**ADDENDUM #2**

**FRUITDALE ROAD AND MCGARIGLE ROAD IMPROVEMENTS AND SR 9  
PEDESTRIAN/BICYCLE SAFETY IMPROVEMENTS PROJECT**

*City of Sedro-Woolley Project No. 2009-PW-02  
Federal Aid Project Nos. ARRA-HPP-7390(001)  
& ARRA-STPE-0009(057)  
WSDOT Contract Nos. TA-3543 & TA-3340*

**April 28, 2009**

SHEET **C6.1**

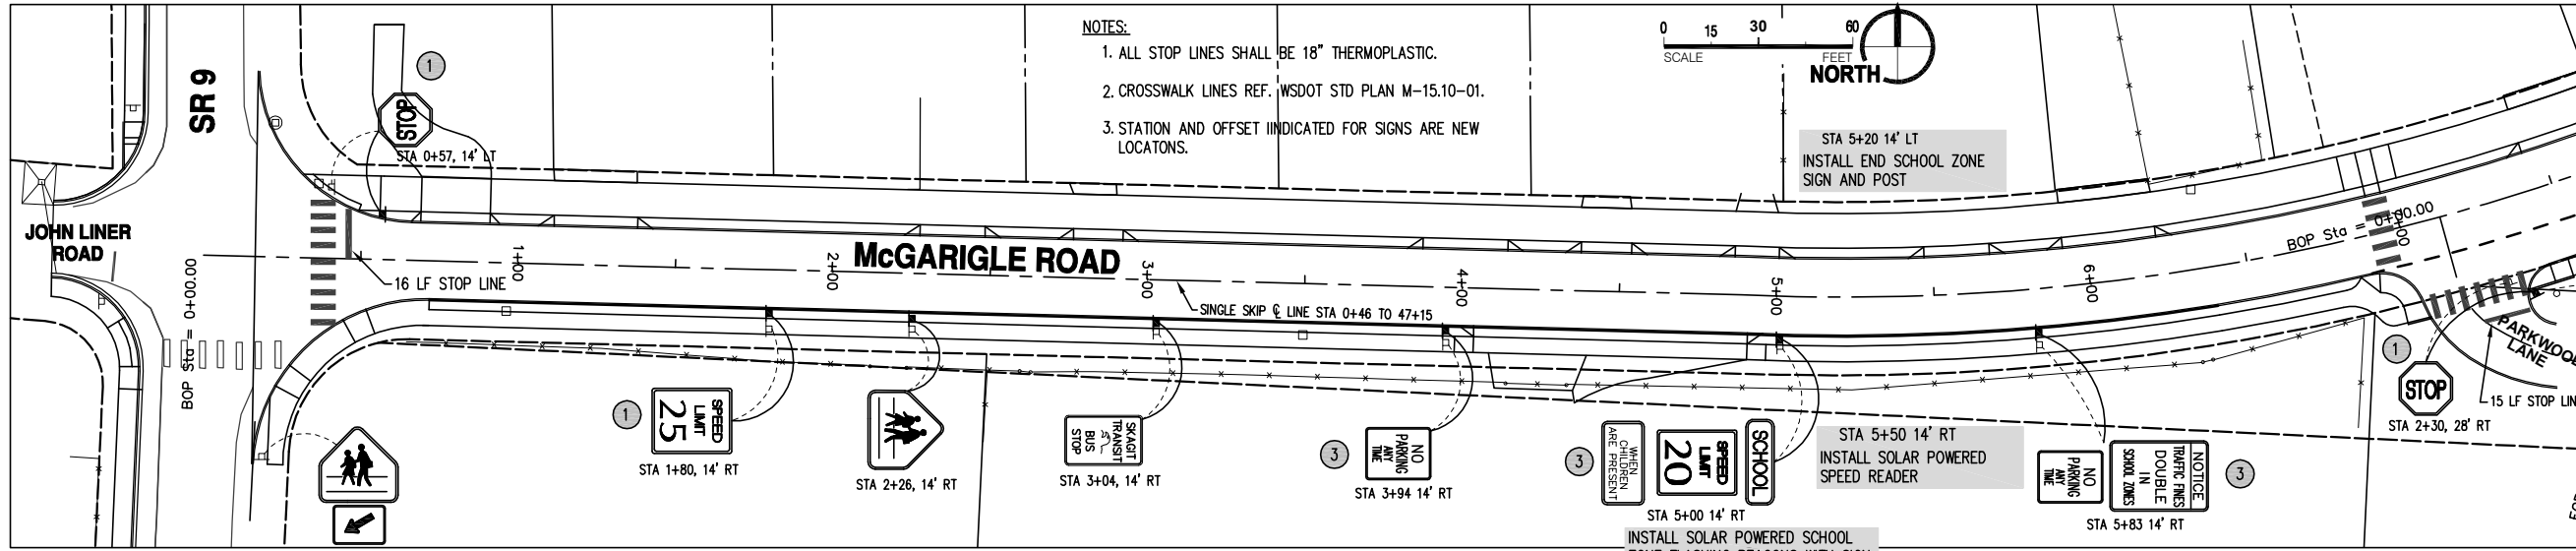
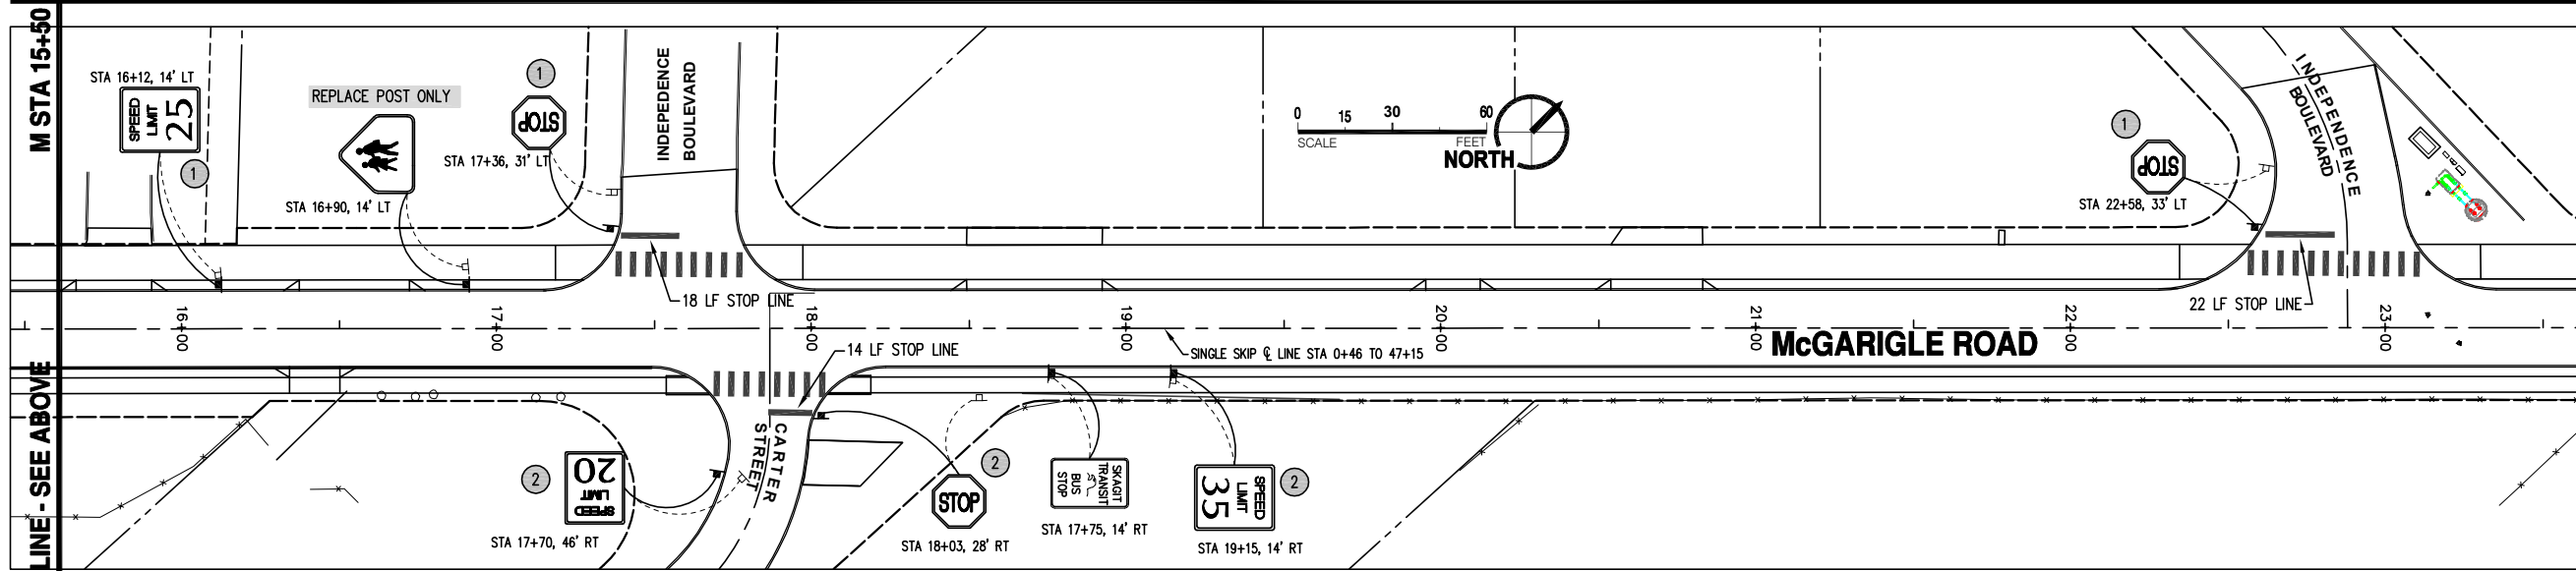
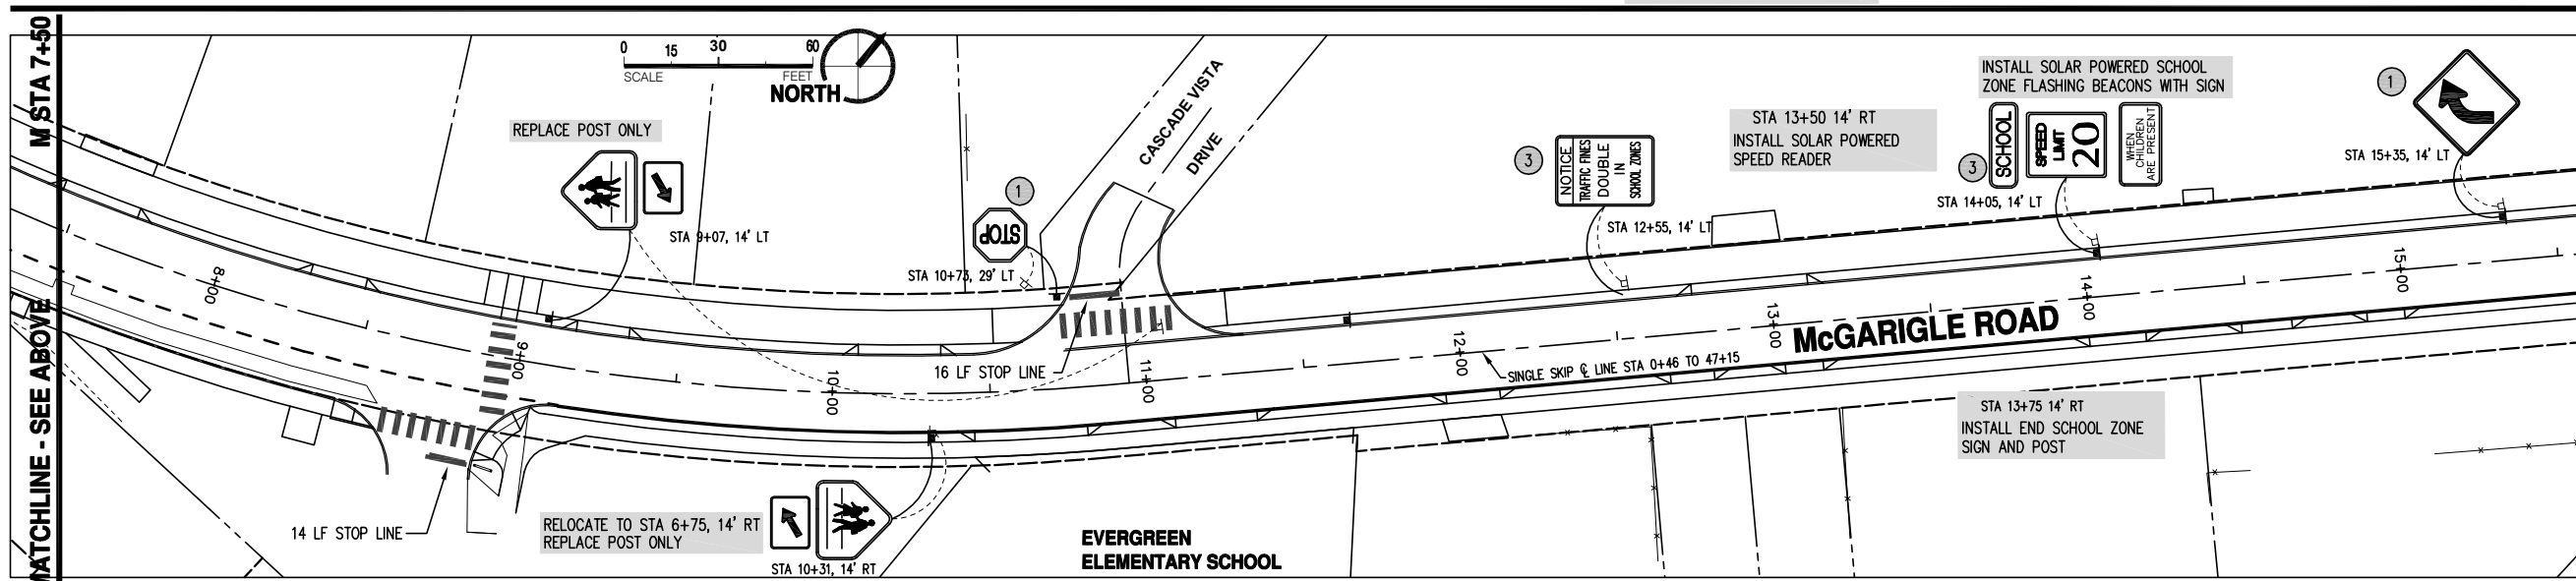
Replacement plan sheets for C6.1, C6.2 and C6.3 are issued with this addendum. Revisions include the replacement of signs to conform with the current MUTCD standards and the replacement of some wood posts with steel posts.

SHEET C6.2

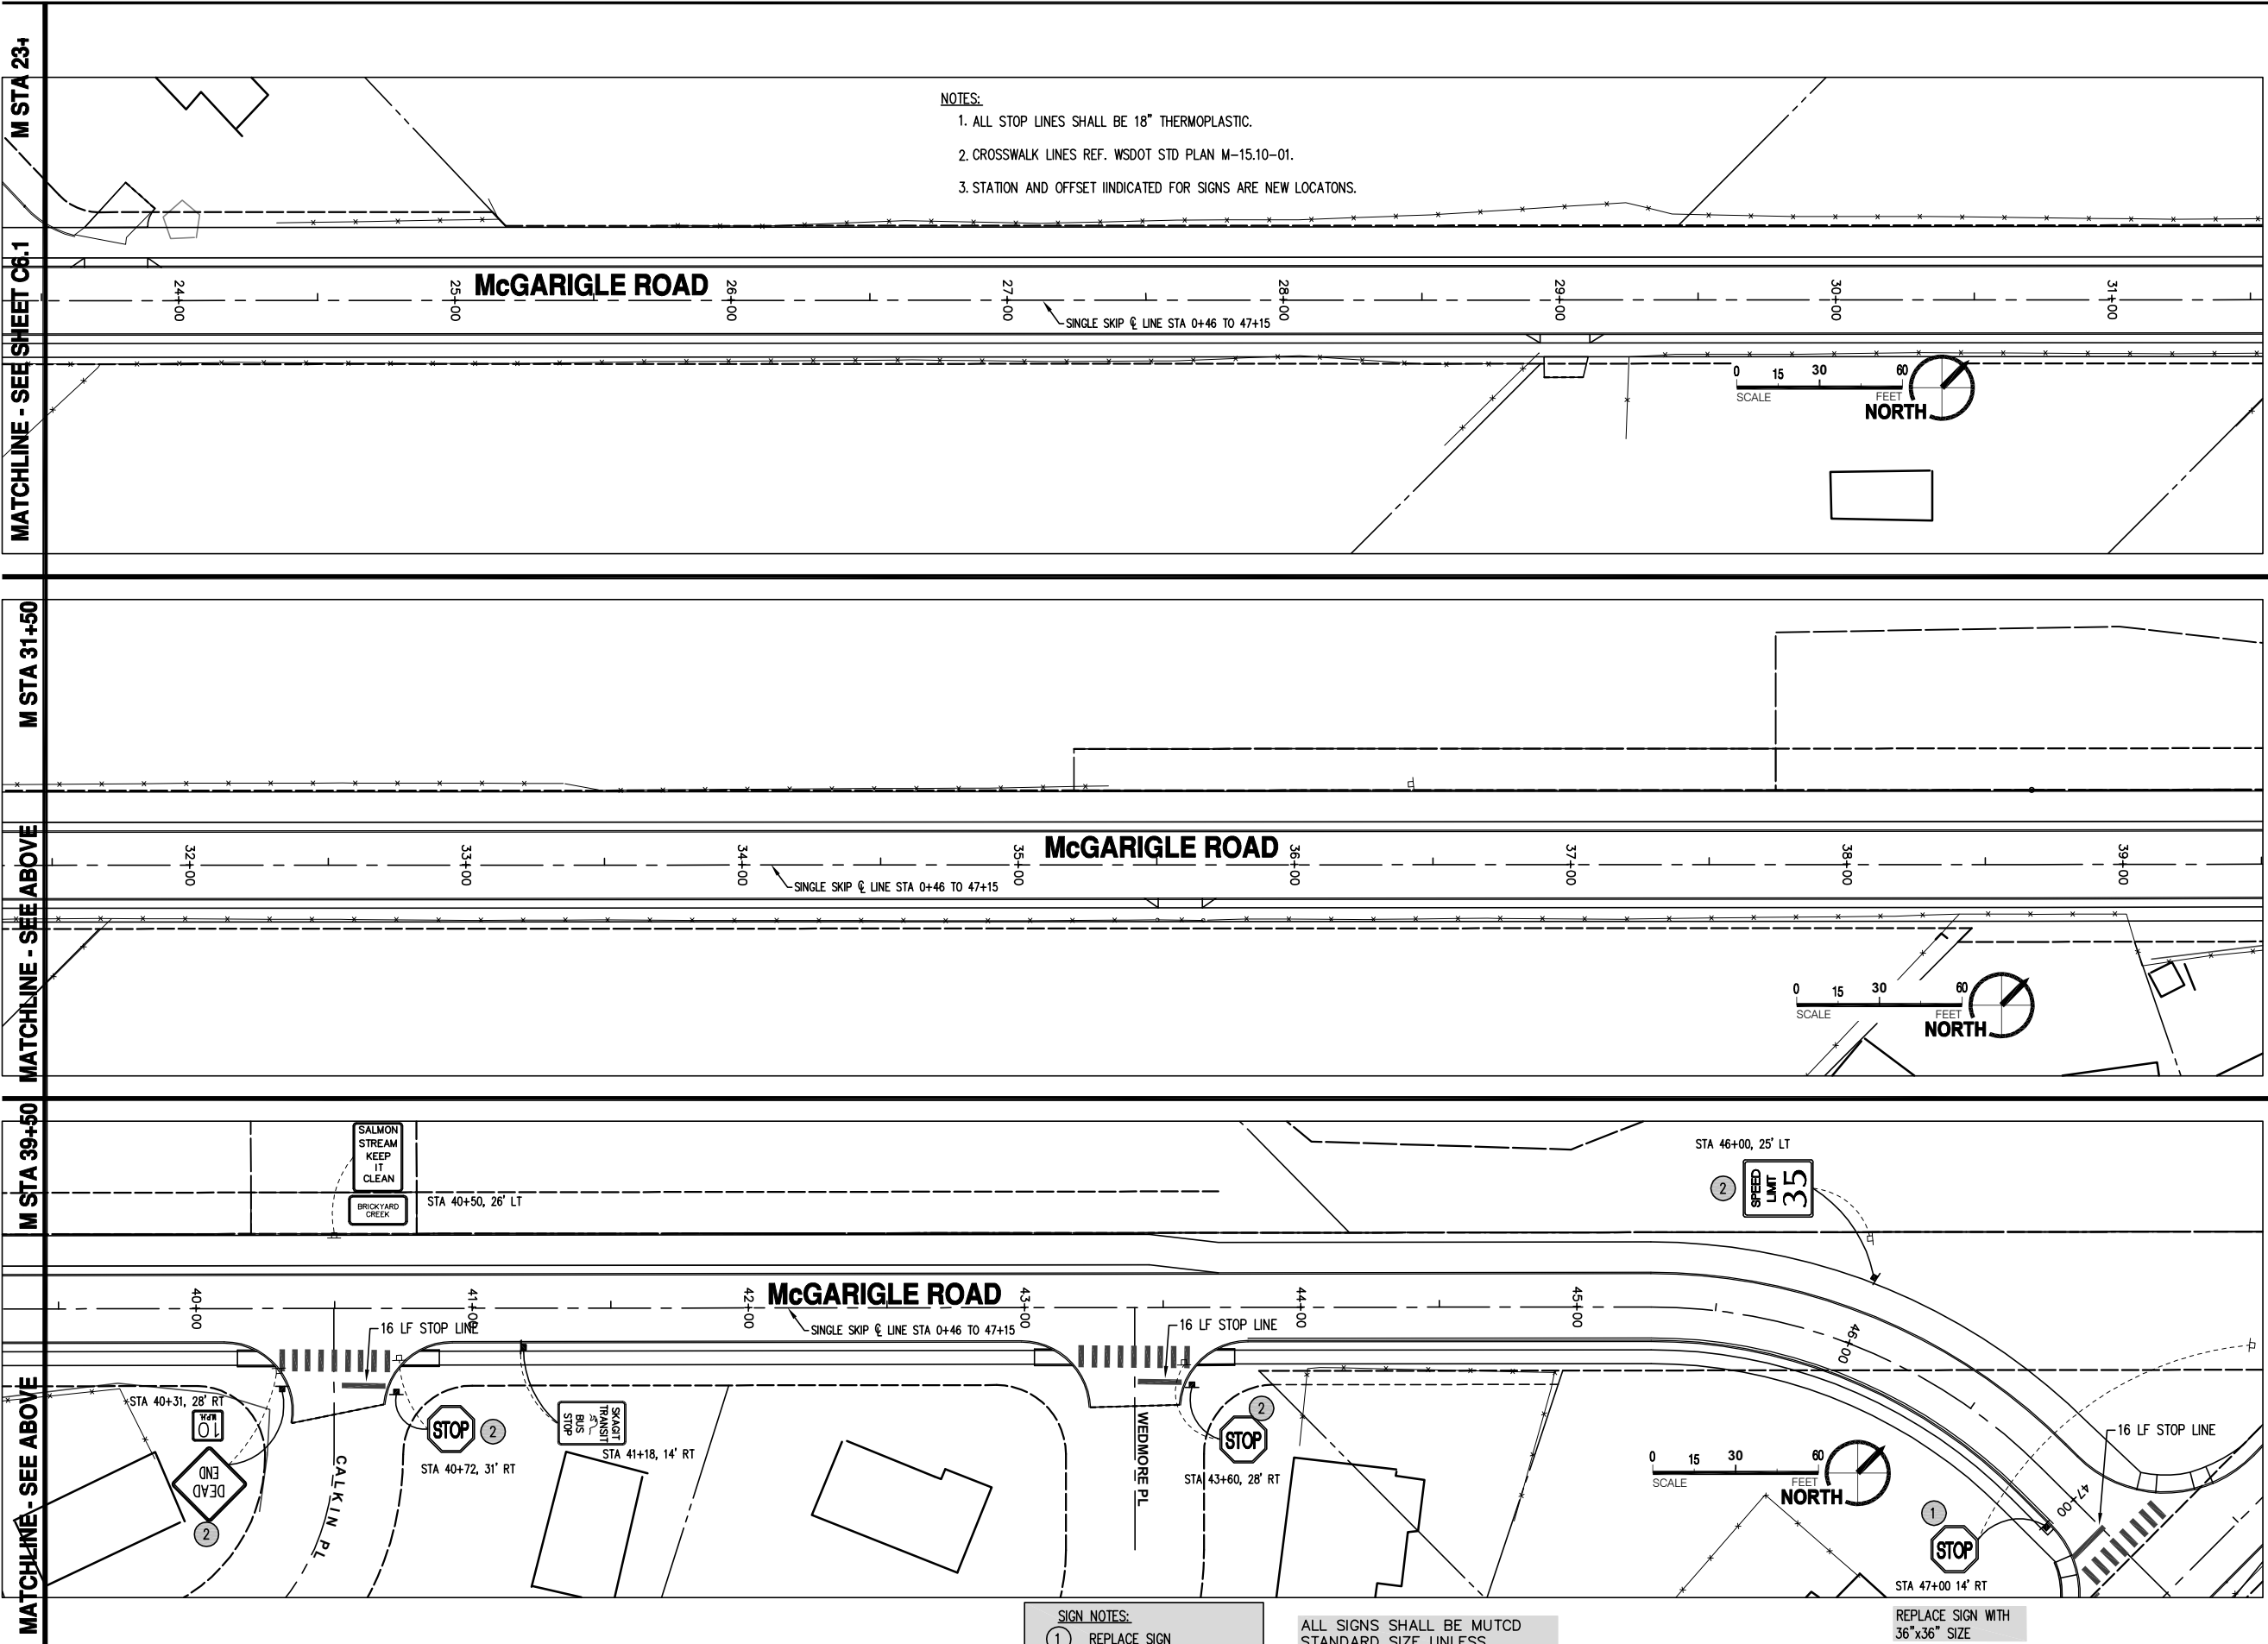
REPLACE SIGN WITH 36"x36" SIZE
